ECN/PCN No.: M1350

<b>Product Description:</b> RJ45 10/100 Base-T Vertical with Magnetic Module	<b>Abracon Part Number / Part Series:</b> ARJ11G Series	<input type="checkbox"/> Documentation only <input checked="" type="checkbox"/> ECN <input type="checkbox"/> EOL	<input checked="" type="checkbox"/> Series <input type="checkbox"/> Part Number(s)
<b>Affected Revision:</b> B	<b>New Revision:</b> C	<b>Application:</b>	<input type="checkbox"/> Safety <input checked="" type="checkbox"/> Non-Safety

**Before    After**

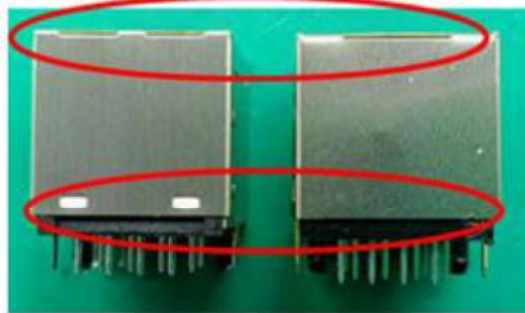
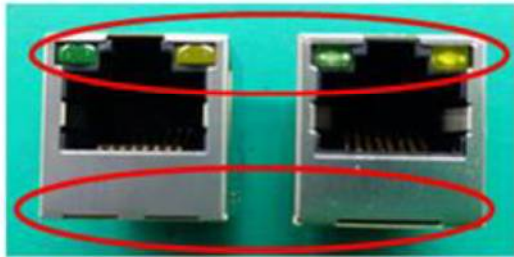
Cosmetic Differences

<b>Cause/Reason for Change:</b> Raw material supply chain required change to different shield/shell.		
<b>Change Plan</b>		
<b>Effective Date:</b> 4/25/2022	<b>Additional Remarks:</b>	
<b>Change Declaration:</b> Outline of MA configuration has changed slightly and attention must be placed on impact to customer panel cutout. There are slight cosmetic differences as well. The changes here do not affect the products electrical function.		
<b>Issued Date:</b> 4/25/2022	<b>Issued By:</b> <i>Gerald Capwell</i>	<b>Issued Department:</b> Engineering
<b>Approval:</b> <i>Syed Raza</i> Engineering VP	<b>Approval:</b> <i>Reuben Quintanilla</i> Quality Director	<b>Approval:</b> <i>Ying Huang</i> Purchasing Director
<b>For Abracon EOL only</b>		
<b>Last Time Buy (if applicable):</b>		<b>Alternate Part Number / Part Series:</b>
<b>Additional Approval:</b>	<b>Additional Approval:</b>	<b>Additional Approval:</b>
<b>Customer Approval (If Applicable)</b>
